**LE SUEUR COUNTY BOARD OF COMMISSIONERS
MEETING AGENDA
March 29, 2019**

STATE OF MINNESOTA
LE SUEUR AND RICE COUNTY BOARDS OF COMMISSIONERS
SEATED AS JOINT DRAINAGE AUTHORITY UNDER STATUTES CHAPTER 103E
FOR LE SUEUR/RICE JUDICIAL DITCH 63

The matter of the Petition of the Minnesota Commissioner of Transportation to modify a portion of Judicial Ditch 63 pursuant to Minnesota Statutes Section 161.28

DATE: January 7, 2019
TO: Darrell Pettis
FROM: Chuck Brandel
CC: MnDOT, John Kolb
SUBJECT: Review of MnDOT 4010-10 TH 99 Water Resource Model & Minor Alternations

TH 99 Culvert Crossings CD 40 and CD 63 Le Sueur County, Minnesota Thursday, July 12, 2018

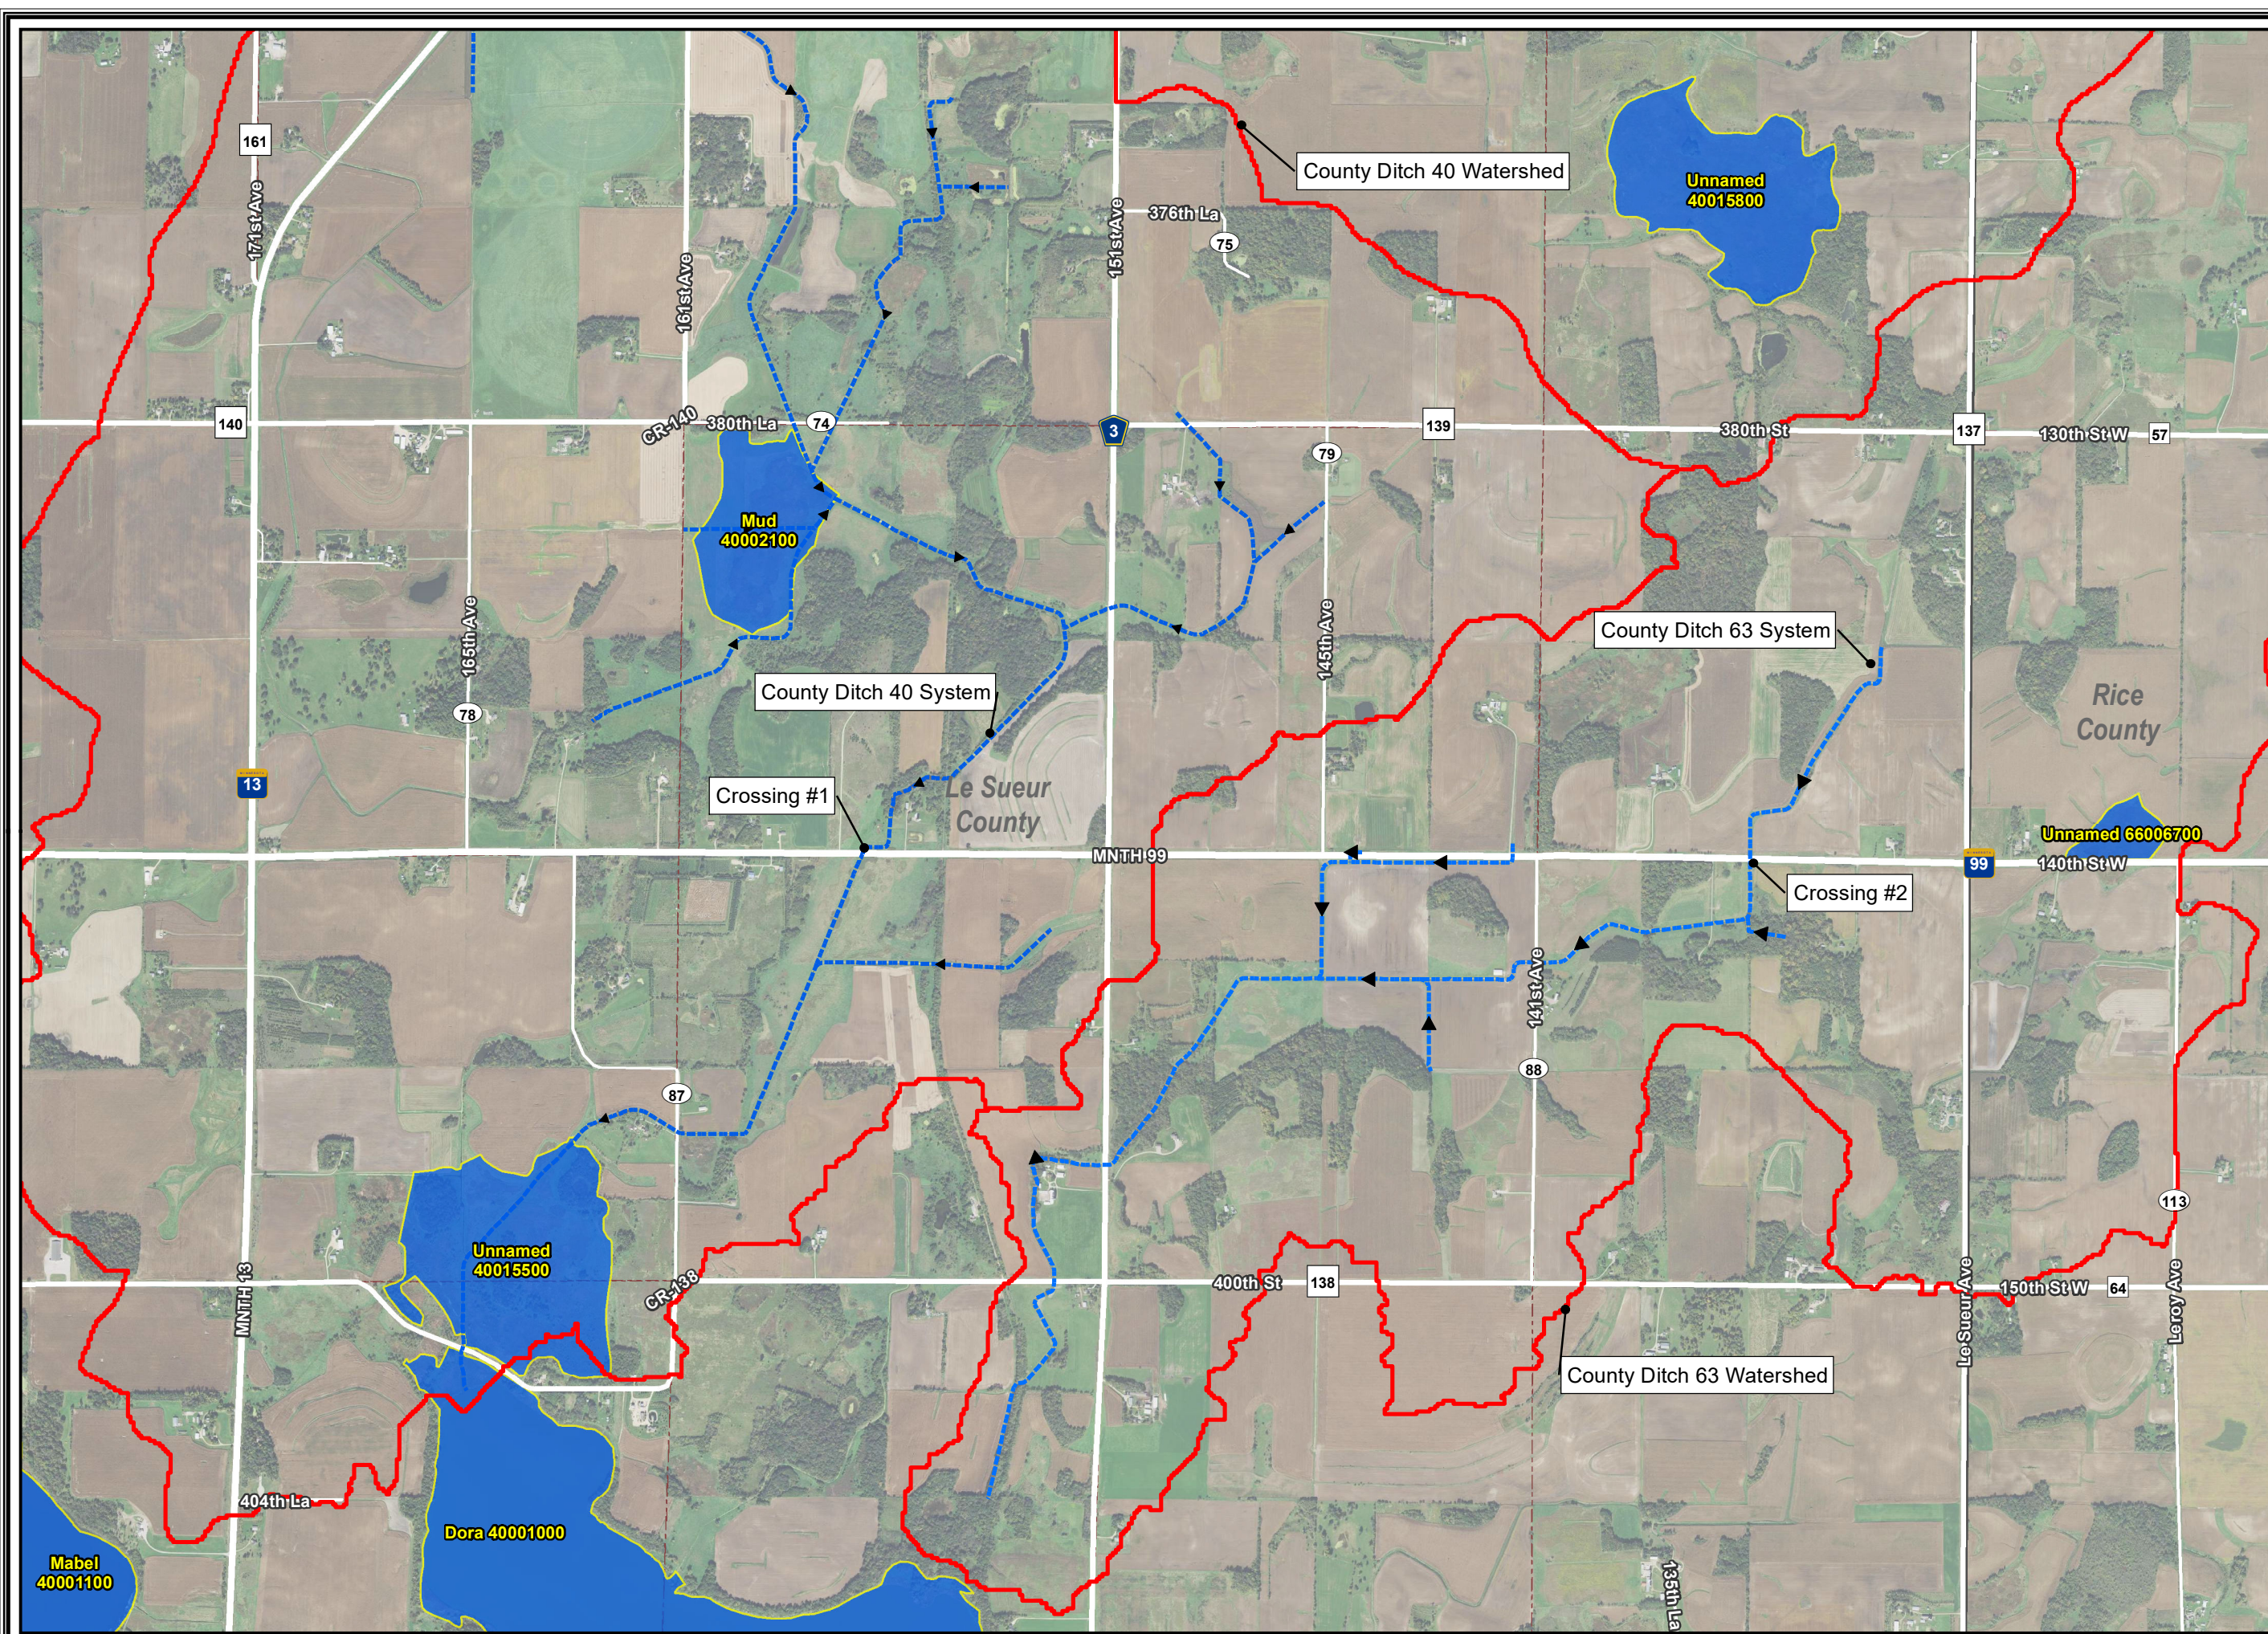
ISG has evaluated the water resources model built for the re-construct and widening of TH 99 in east central Le Sueur County, specifically looking into two culverts planned to be replaced under the highway that convey water through county ditch systems, CD 40 and JD 63.

Based on ISG's review of the model from MnDOT and the models developed by ISG for JD 63, it was determined that the alterations made to the JD 63 crossing of TH 99 affect and impair the efficiency of the drainage system by increasing flood waters downstream of the TH 99 crossing. From developed models, the downstream peak flood elevations are increase by 0.36-feet (4.3-inches) on the 10-year rainfall event producing increased pressures on the downstream crossing. Option 3 is recommended to be implemented into MnDOT plans as a precondition as it is potentially the least expensive option. MnDOT should modify their request to ensure plans for TH 99 will not affect or impair the efficiency of the drainage system

ISG recommends that MnDOT modify their application for minor alterations to include Option 3. If MnDOT modifies their request to include an option where the modification no longer effects or impairs the drainage system, such as Option 3, the drainage authority should grant approval for the modifications. If no modifications are made the drainage authority should deny the request for minor alternations.

Driveway Crossing
CD 63
Le Sueur County,
Minnesota
Monday, January 07, 2019

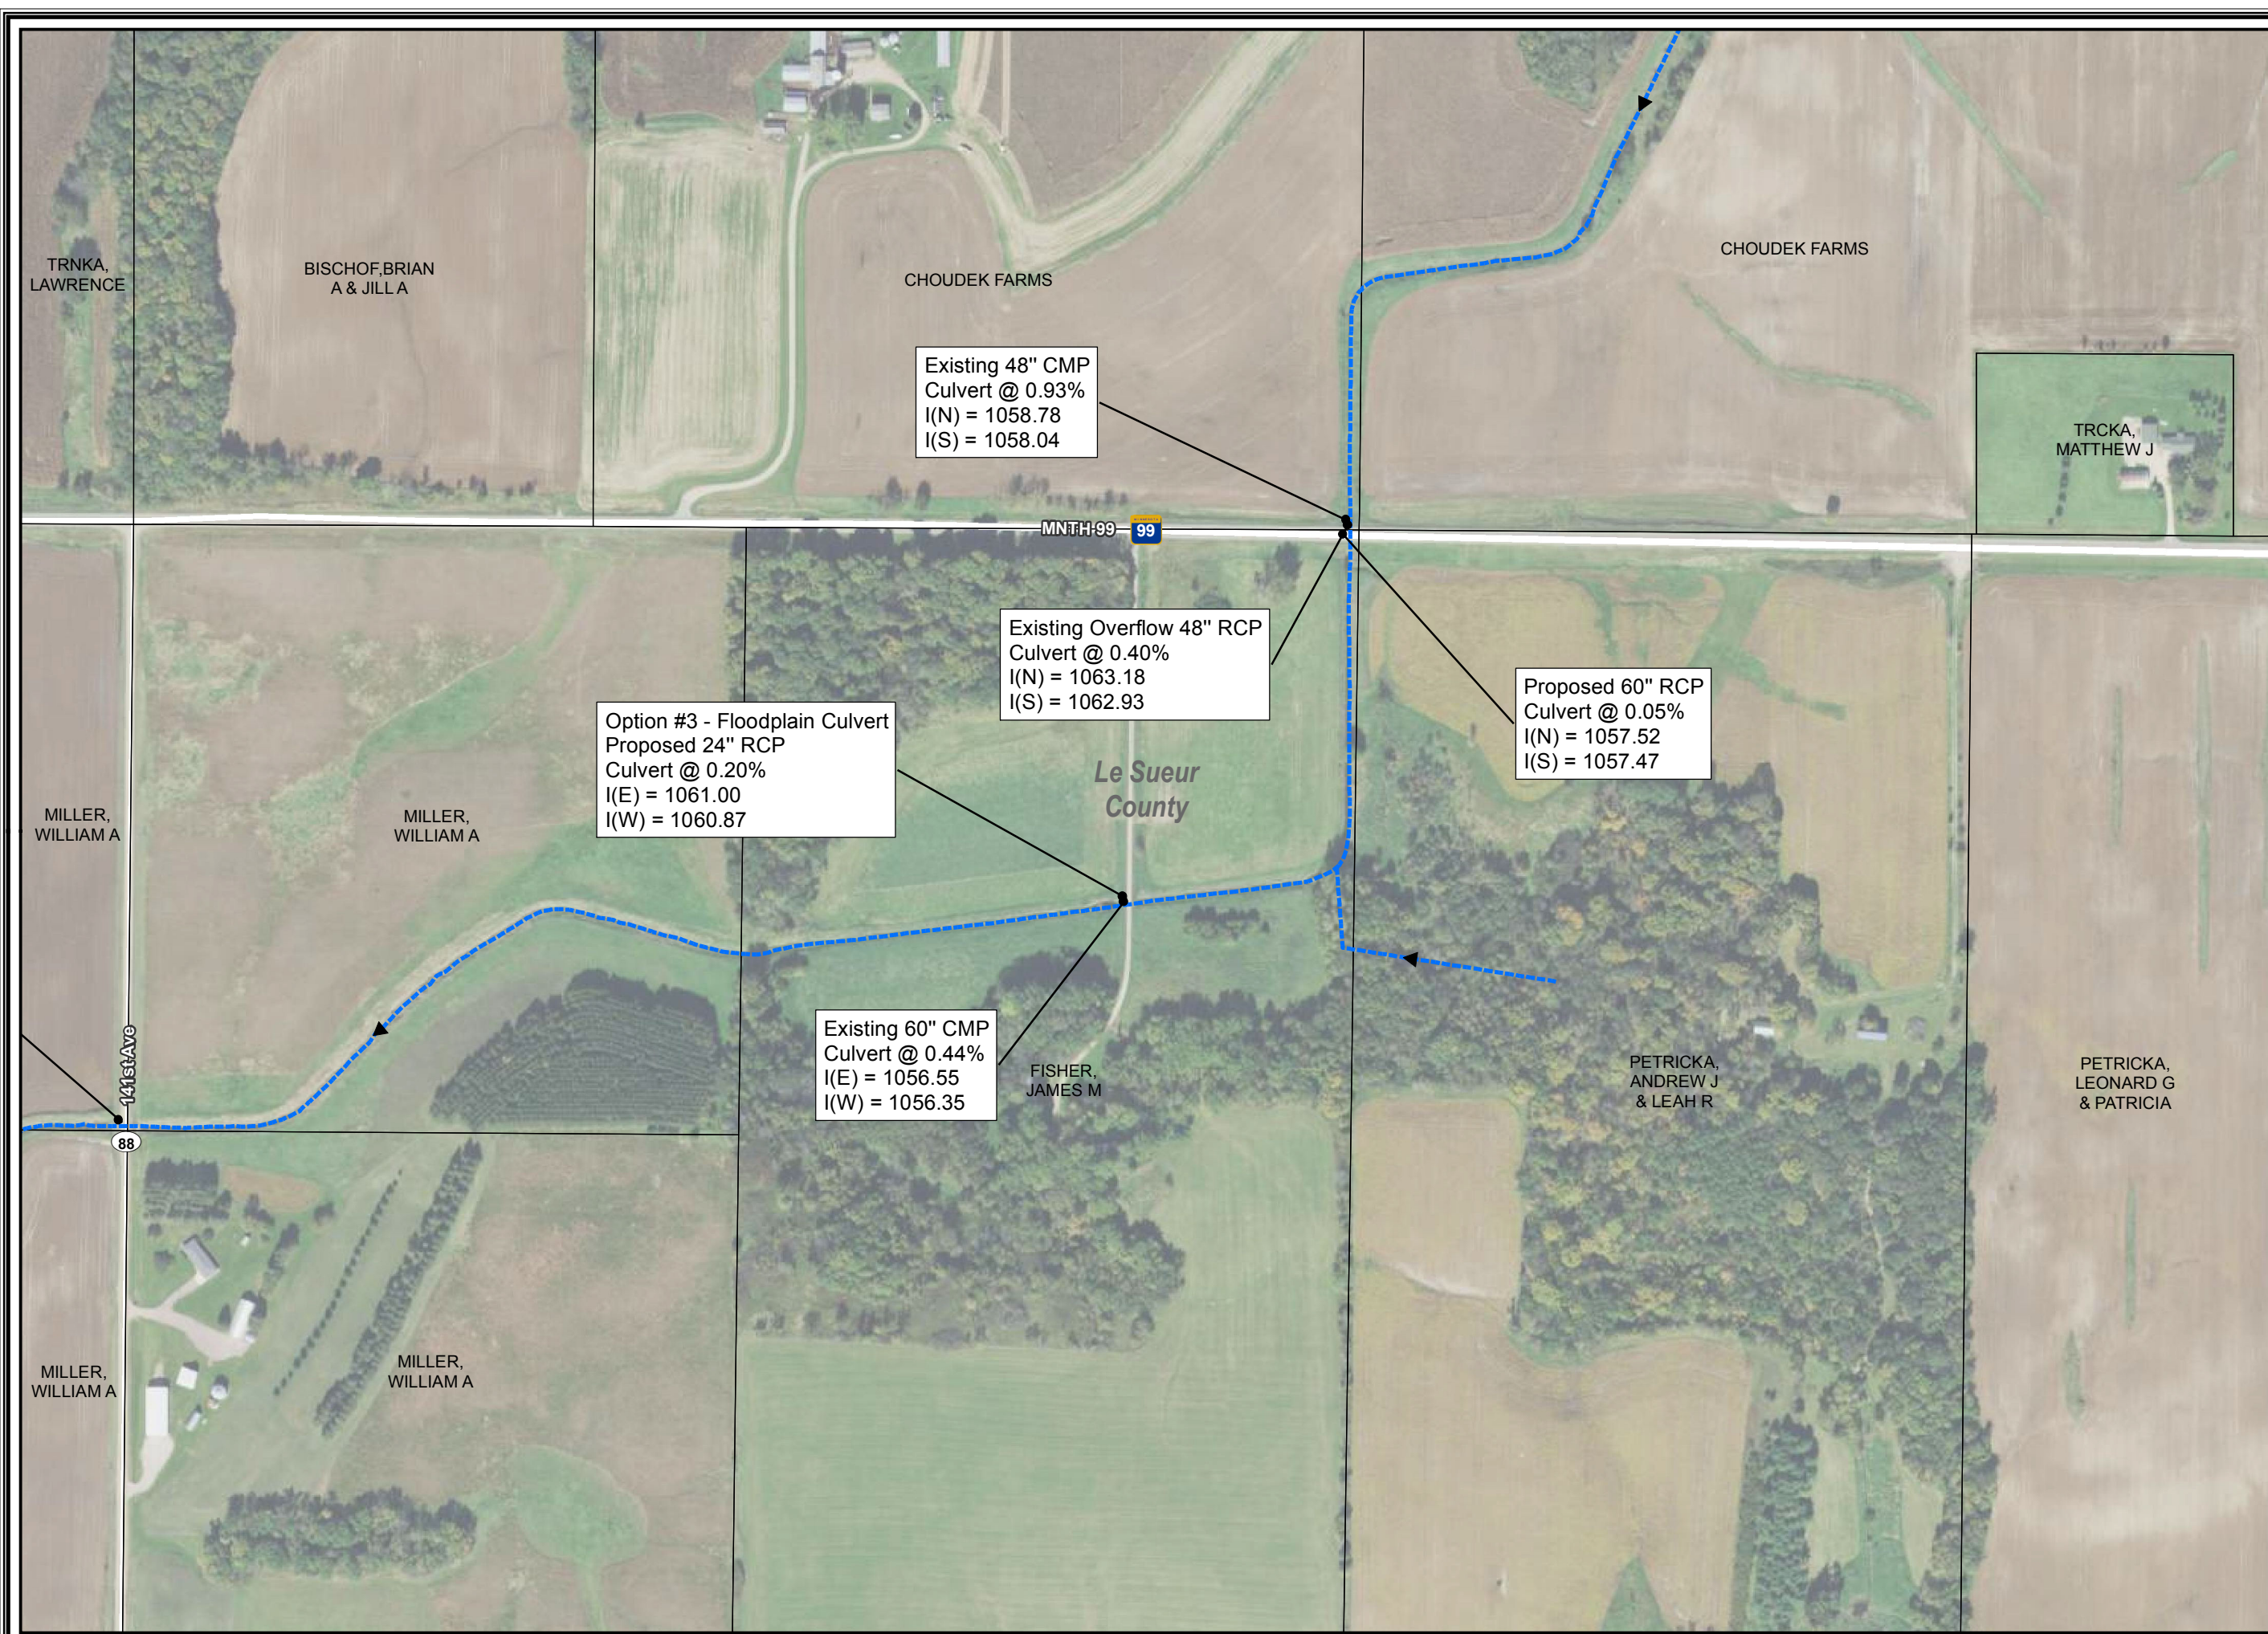
It was brought to the attention that the culvert downstream of the TH 99 crossing on JD 63, a private driveway, overtops regularly and to ensure the proposed changes do not increase pressures on private property ISG has extended the model to include the private driveway downstream of the proposed project on TH 99. Currently, the private driveway consists of a 60-inch corrugated metal culvert with design characteristics noted below.

As noted in the table, there is an increase in peak water elevation at the driveway on all storm events due to the proposed changes on the culvert under TH 99. From LiDAR, the elevation for the top of the driveway was noted to be 1067.45. Therefore, the driveway according to the developed model indicates that the driveway overtops on the 10-, 25-, 50-, and 100-year storm events for the proposed and existing models.

Placing an additional smaller culvert at a higher elevation in the floodplain at the driveway crossing is a viable option to more effectively drain area and have less likelihood of overtopping during larger storm events. Placing a 24-inch concrete culvert at the elevation 1061.00 would reduce pressures on driveway crossings. Below indicate the peak flood elevations with the proposed addition.
